SPRINGS LOFTS

RFI#: 37 Date: 1/23/2012 Job: EB-02 Keller Springs Lofts Phone: 877-777-5115

Date Required: 1/25/2012 Request: On sheet P-3.0C the main sanitary trunk line is shown running in the center of the corridors. It is 6" running north along the east side of the garage. It joins another 6" running east along the north side of the garage. So we have a 6" joining with another 6" but there is no designation as to the size of the line after that until it meets the 10" that leaves the building. Sheet P-3.0E gives no designation to the size of this line either. I feel this may be an oversight and the intention would be to have the large to an 8" after the (2) 6" lines merge. Please advice and respond as we are going to be installing these lines in the next two days.

Subject: Purposed relocation of oil Separator

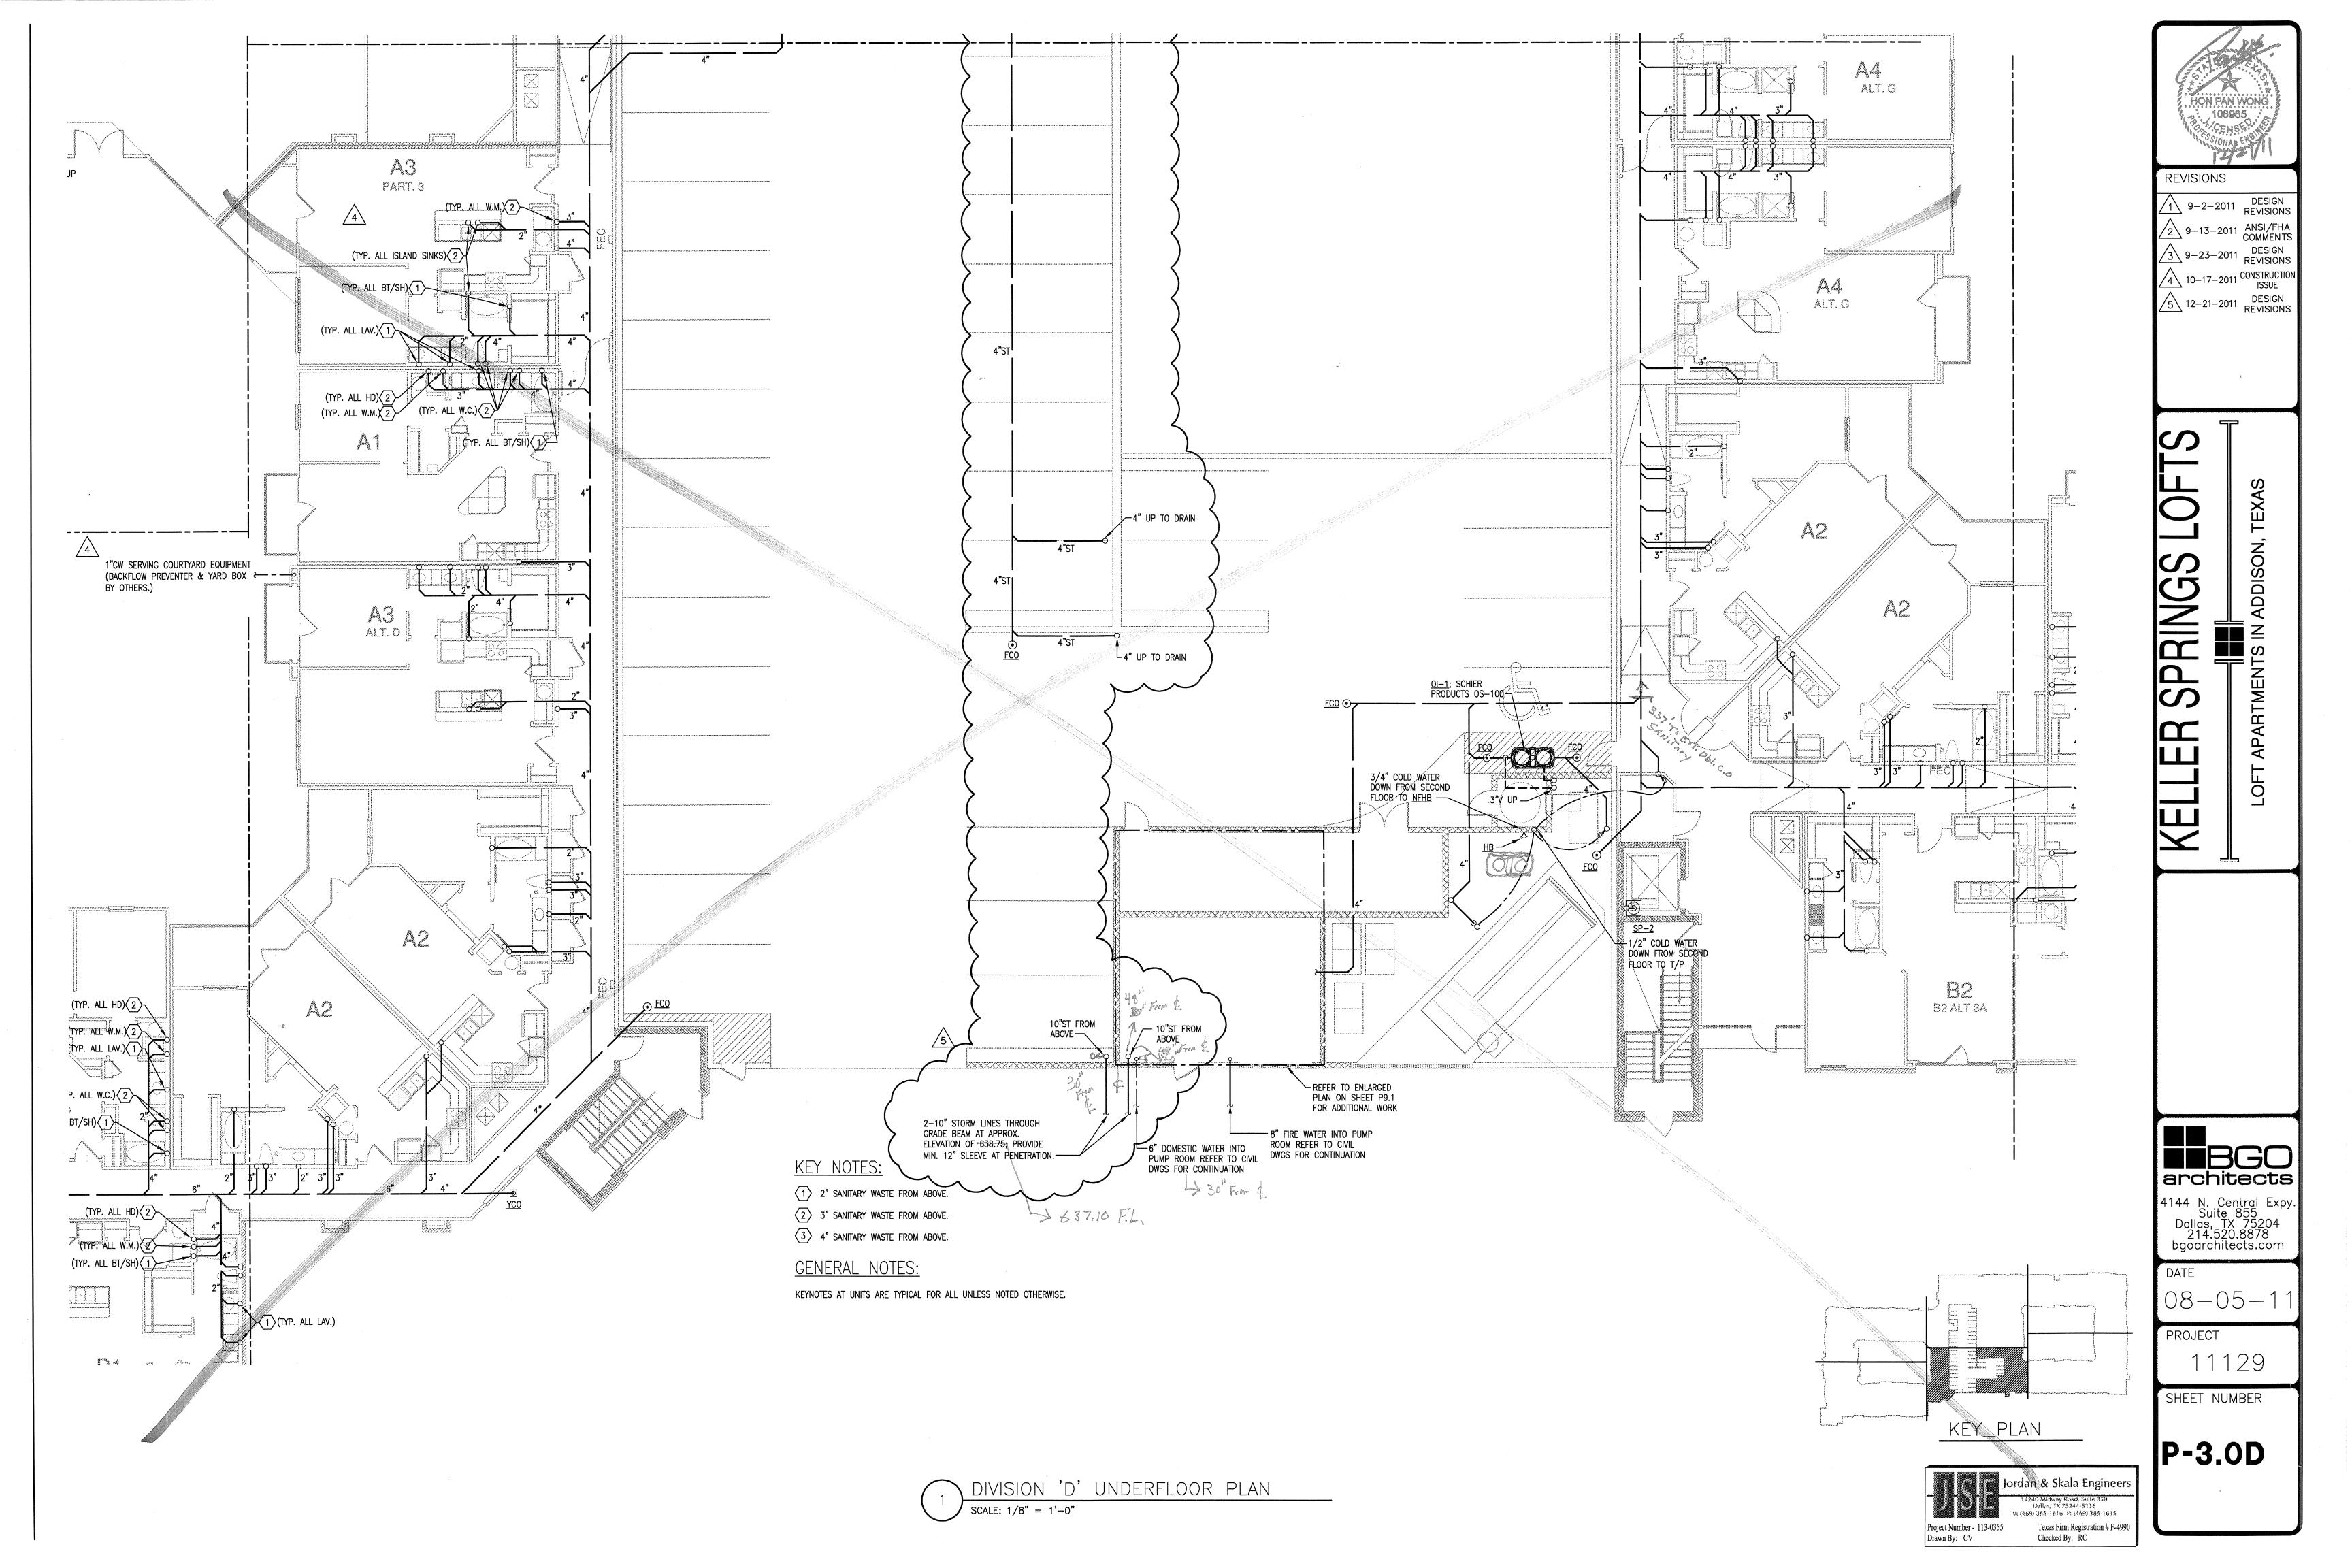
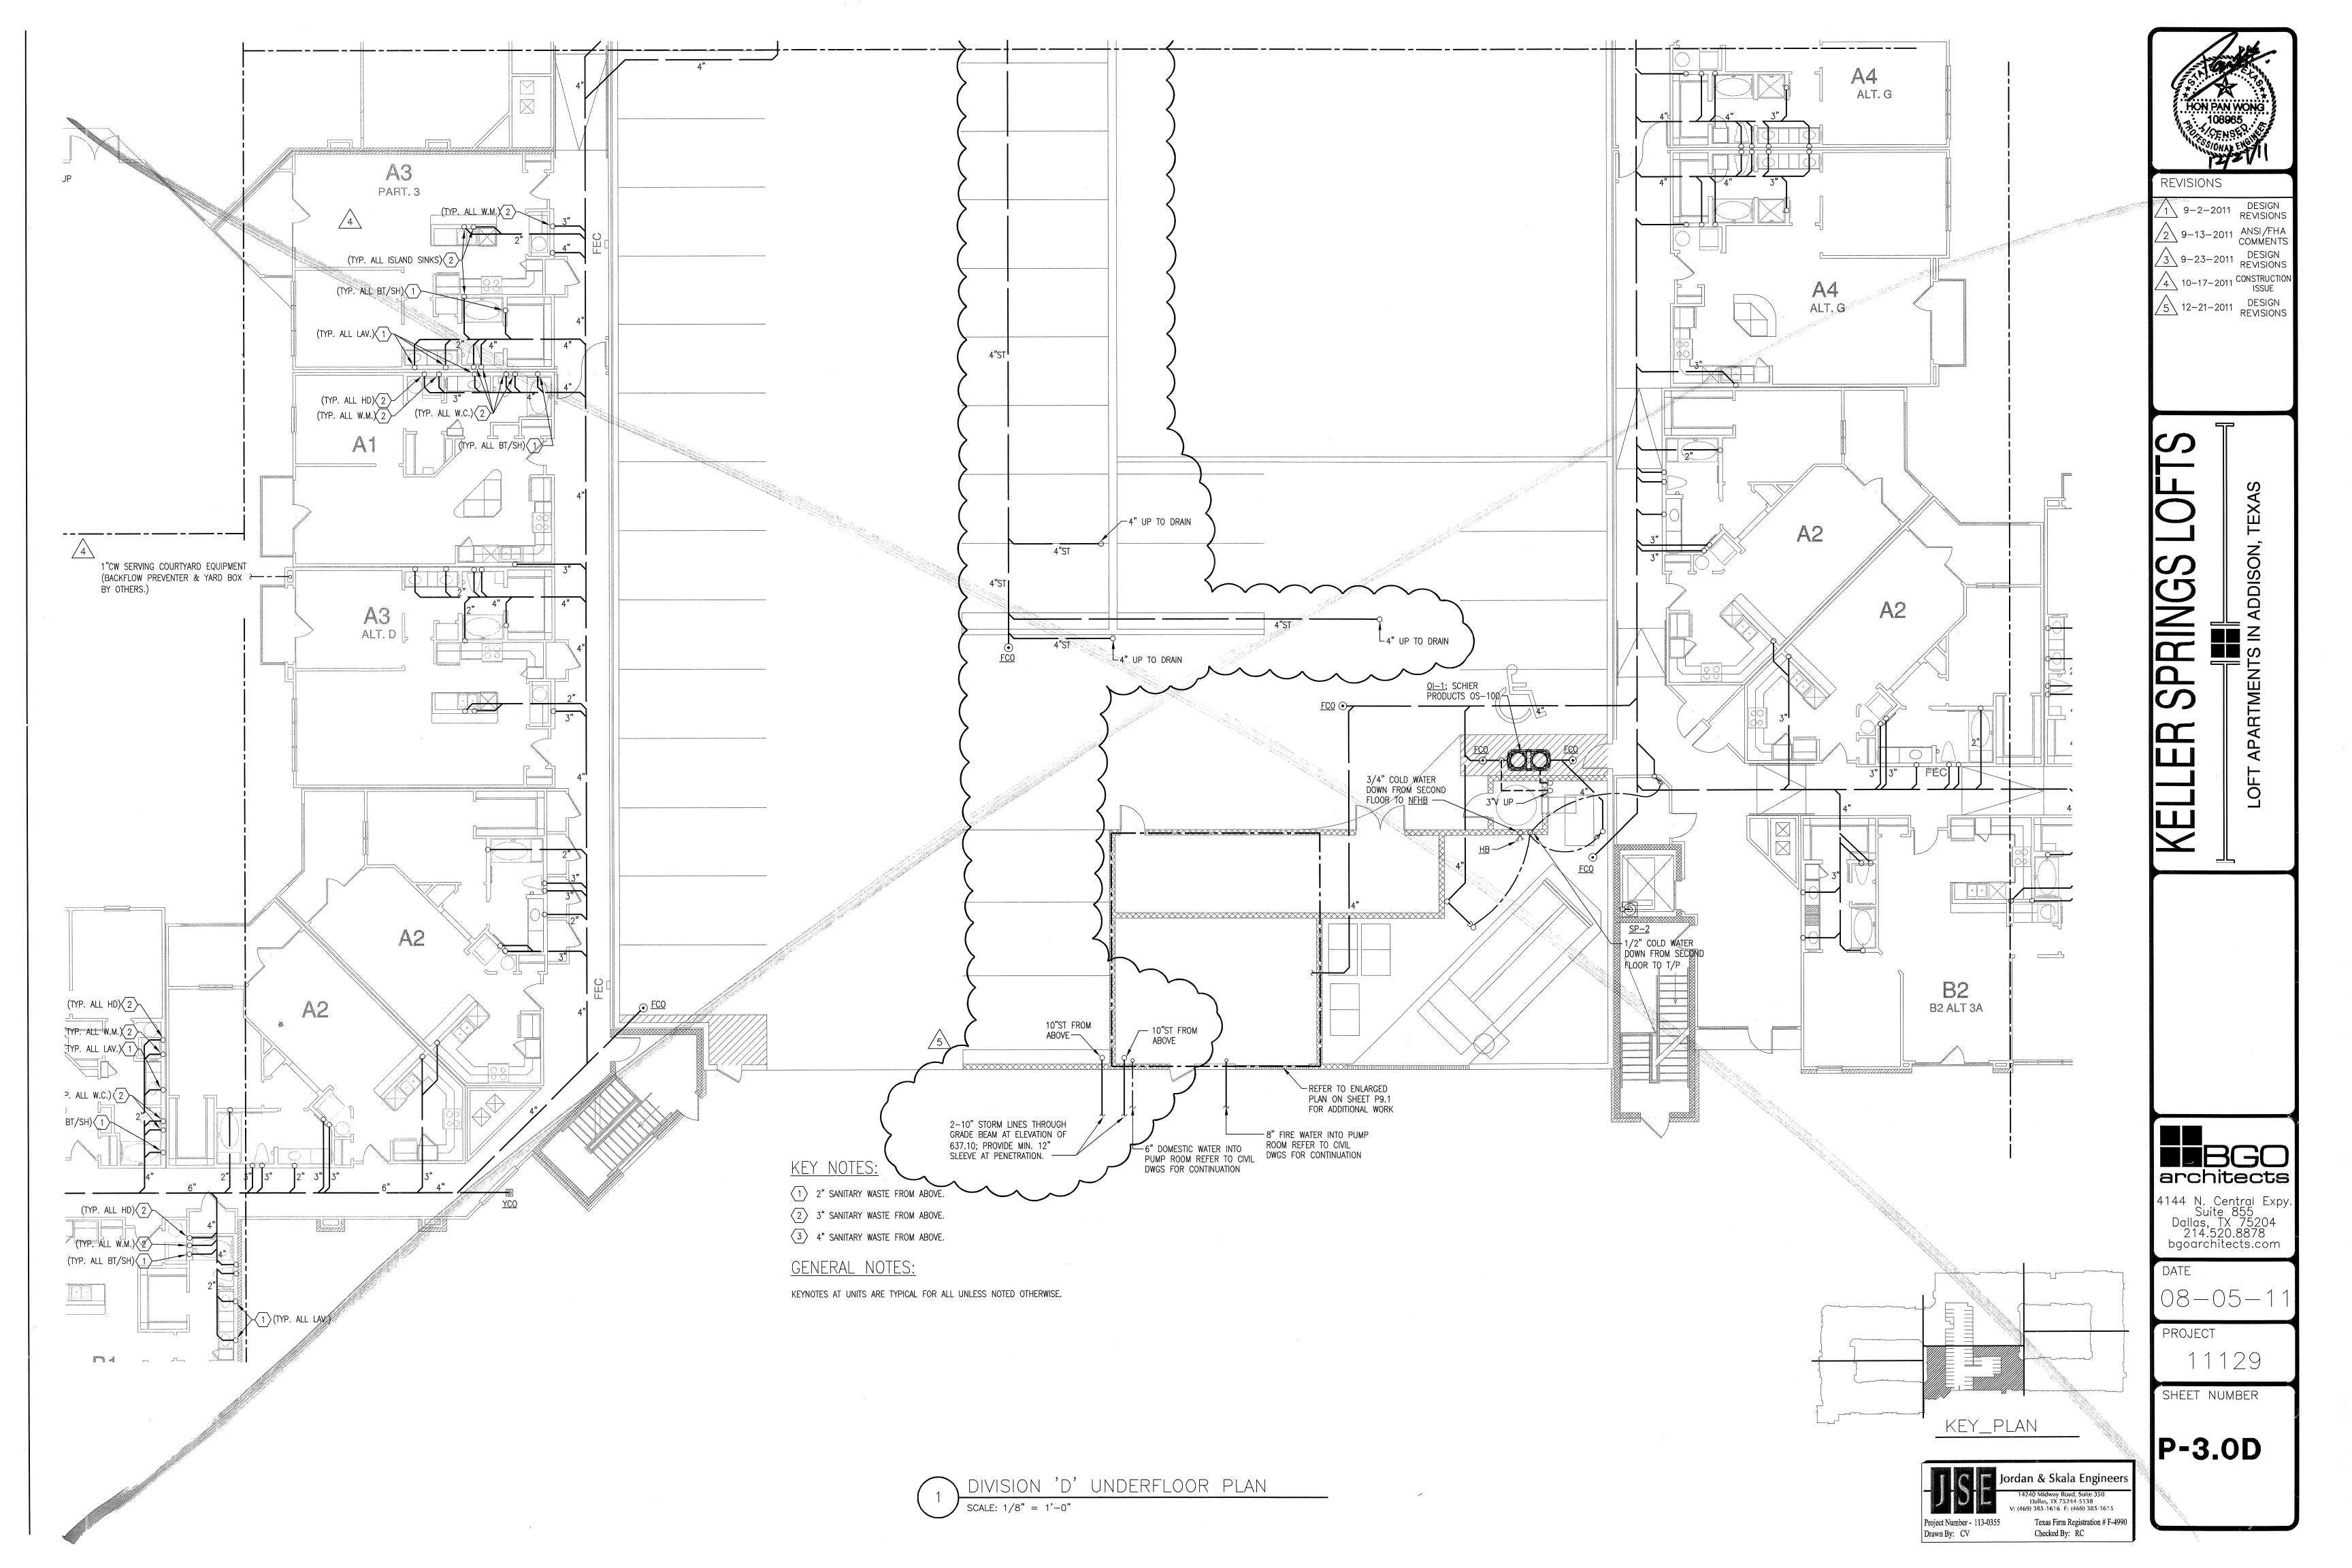
Sheet P-3.0D shows the OS-100 (oil separator) located in the resident walkway from the garage to the building. I believe this will almost certainly be a tripping hazard, and purpose we move its location to the trash compactor room. I have an attached detail showing the location my plumber and myself think would be an alternative location. Please review and advised Requested by: Bryan Pickler

Embrey Partners, Ltd. JSE takes no exception to the proposed re-location of the oil separator. New location will be reflected on Design Revision plans dated 01-17-2012 (Delta 6). Russell Cox - Jordan & Skala Company
